October 13, 2017

**Subject: Addendum to Workplan for  
Additional Soil and Soil Vapor Investigation  
1228-1236 17<sup>th</sup> Avenue, Oakland, California  
EIS Project # 1652-2A  
ACDEH Case No. RO0003243**

**Figure: 3**  
EIS Project: 1652-2A  
June 27, 2017

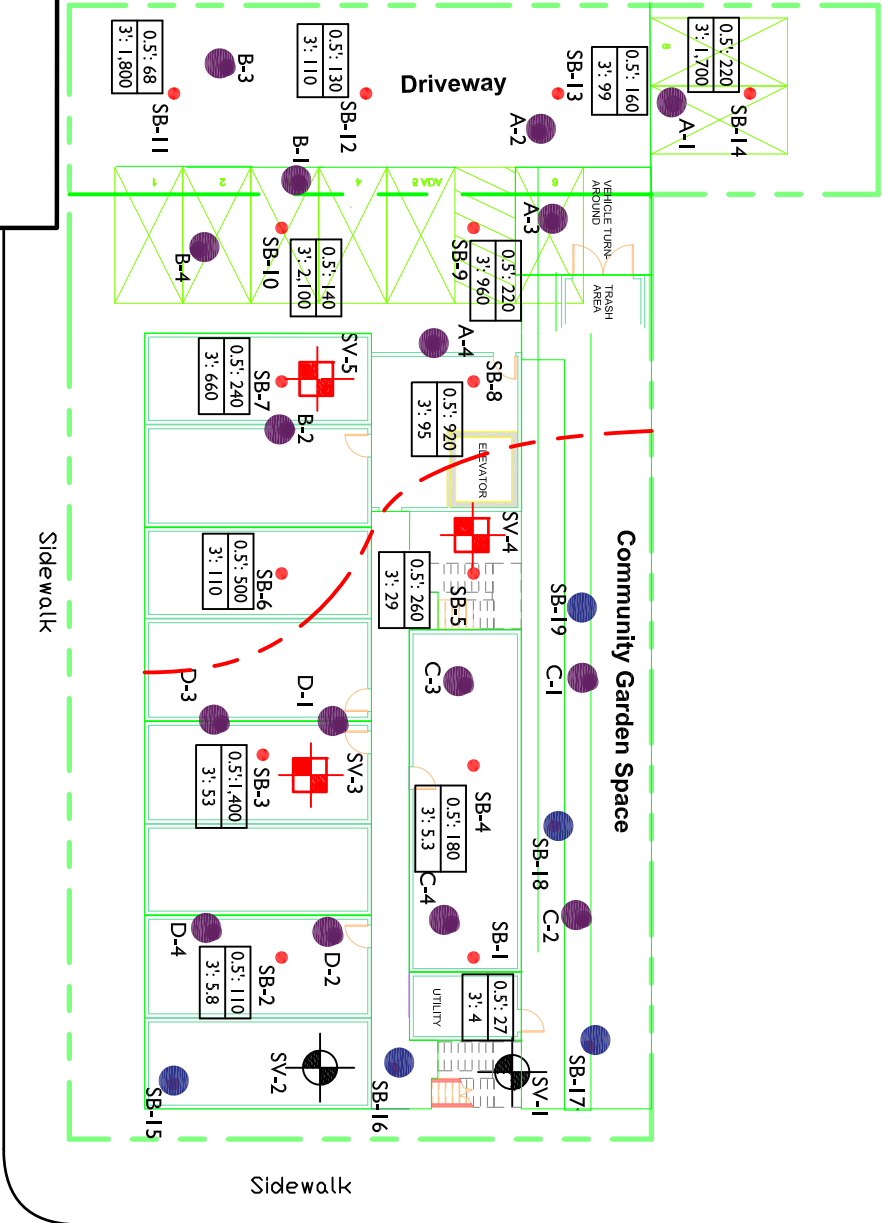
1. **Site Cut / Fill and Surplus Soil Management** – I recall that soil from beneath lead contaminated soil in the central portion of the site will be excavated and either reused onsite, or off-hauled as potentially clean fill to another site, and that the overlaying lead contaminated soil will be replaced into the hole created, and subsequently capped beneath the proposed concrete slab for the redevelopment. Please clarify this. It is additionally understood that the A- and B-series soil bores which are proposed to be composited in the laboratory, will be analyzed for TPHg, TPHd, TPHmo, PAHs, and CAM17. What is the intended use of this soil? Will this be off-hauled, or used as fill beneath the proposed concrete slab cap? If we are concerned about the listed contaminants in one area of the site for onsite reuse, are we not interested in them below the future concrete slab cap at the remainder of the site?

- 2. Clean Fill Characterization** – As indicated, potentially clean soil beneath lead contaminated soil in the central portion of the site will be excavated for one of

several reasons. How will the limits of that soil be defined? At present the majority of three foot soil samples contain lead above the residential lead ESL of 80 milligrams per kilogram (mg/kg), and thus the lower extent of soil contaminated with lead has not been defined. Do you intend on defining upper and lower (depth) low lead concentrations prior to excavation (preferred), or with clean upper confirmation samples concurrent with excavation, and post-excavation lower confirmation samples? The addition of soil bores to characterize this now would be one way to proceed. (I can request in an approval letter, if this is how you would like to proceed, rather than another work plan modification, but if you intend to do another way, let me know.).

*The mat foundation at the site will require approximately 18 inches to 2 feet of cut below existing grade across a large portion of the site. Site grading will be designed to segregate and stockpile the relatively shallow lead-impacted soil (to a depth of 1 to 2 feet bgs or below current grade) scraped from the approximate eastern half of the Site. This stockpile will be temporarily staged in the western half during grading activities. The plan is to excavate and off-haul sufficient soil in the eastern half from below the scraped-away, uppermost lead-impacted soil in this area to*

*accommodate the total volume of lead-impacted soil to be moved over from the western half, including the segregated stockpile from the eastern half. It is assumed that once the upper 1 to 2 feet of lead impacted soil is scraped from the eastern half, excavation in this portion of the Site during grading activities may extend to depths of 5 to 6 feet bgs (i.e., below current grade) to accommodate lead-impacted soils “flopped-over” from the western half. Such lead-impacted soils will be graded across the Site and capped by the mat foundation and hardscape of the future development.*

*It is intended that the off-hauled soil from the eastern half would be characterized or profiled for disposal in a Class III sanitary landfill or perhaps as “clean fill” to be reused at another construction site. This material would be pre-profiled for landfill acceptance or reuse by subdividing the eastern half of the Site into quadrants and collecting 4-point composite samples from each of the four quadrants at depths of approximately 3.5 and 4.5 feet below current grade. The depth of the planned excavation in the eastern half is expected to be up to 5 to 6 feet below existing grade. This pre-profile sampling would be performed as part of the corrective action plan to be implemented during grading activities for the construction project.*

*The composite analyses for the proposed A- and B- series borings located in the western half of the Site are designed to further characterize the soil in this area for potential additional contaminants (beyond existing lead data). The lead-impacted soil in the western half (including that scraped, segregated and stockpiled from the eastern half) will be regraded across the Site, including backfilling the excavated area in the eastern half. Final grade across most of the Site would be approximately 18 inches to 2 feet below existing grade to accommodate the mat foundation. The regraded fill surface across the Site would contain elevated lead concentrations (i.e., above both the residential ESL), which would be capped by the mat foundation and the hardscape of the driveway, courtyard and concrete-lined, raised planter of the community garden. The intent is to keep the lead-impacted soil onsite beneath the mat foundation and hardscape to avoid the high cost of disposing such material in a Class I Hazardous Waste landfill.*

*Regarding your question about our sampling for potential additional contaminants (TPH-g/d/mo PAHs, CAM 17 metals) in the western half (composite samples from A- and B-series borings), but not in the eastern half, upon further consideration we will revise our sampling plan to collect similar samples in the eastern half for consistency across the Site. The analysis of screening-level composite samples is intended as an additional level of assurance that other potential contaminants are not present in soils to be graded across the site. We propose to advance four C-series borings in the northeastern quadrant of the Site and four and D-series borings in the southeastern quadrant (see attached figure). Single samples will be collected from each of the borings at a depth of approximately 1.0 feet bgs, with the samples organized in the laboratory into two 4-point composite samples representative of the uppermost soils in the eastern half. As noted above, during grading activities the uppermost 1 to 2 feet of soil having lead impacts will be scraped away from the eastern half and temporarily stockpiled on the western half to await over-excavation of the eastern half, after which lead-impacted soils will be flopped over into the excavation from the western half.*

*Based on soil data collected to-date, the soil beneath the lead-impacted soil in the eastern half appears to be "clean" below a depth of approximately 2 feet bgs (3-foot bgs samples have low, below-ESL lead concentrations). Once the uppermost lead-impacted soil is scraped-away and stockpiled separately on the western half, a grid of discrete subsurface samples would be collected and composited from the eastern half as described above, with the samples analyzed for appropriate parameters to pre-profile the soil to be excavated for ultimate landfill acceptance. EIS is considering using an XFR lead analyzer during grading activities to confirm that the cut is deep enough to remove soils with significant lead impacts and thereby assure that off-hauled soil can be disposed in a Class III landfill, or if suitable, reused as clean fill at another construction site. Use of the XRF analyzer concurrent with the excavation is proposed instead of actual confirmation samples to define the upper boundary of soils to be disposed in a Class III sanitary landfill, or if suitable, reused as clean fill on another construction site. Post-excavation confirmation samples from the bottom of the excavation are not considered appropriate to confirm vertical attenuation of lead to below ESL (or background levels), as the entire site is to be capped by the mat foundation and hardscape. As noted above, pre-profile sampling of the soil to be off-hauled would be performed as part of a corrective action plan to be implemented during grading activities.*
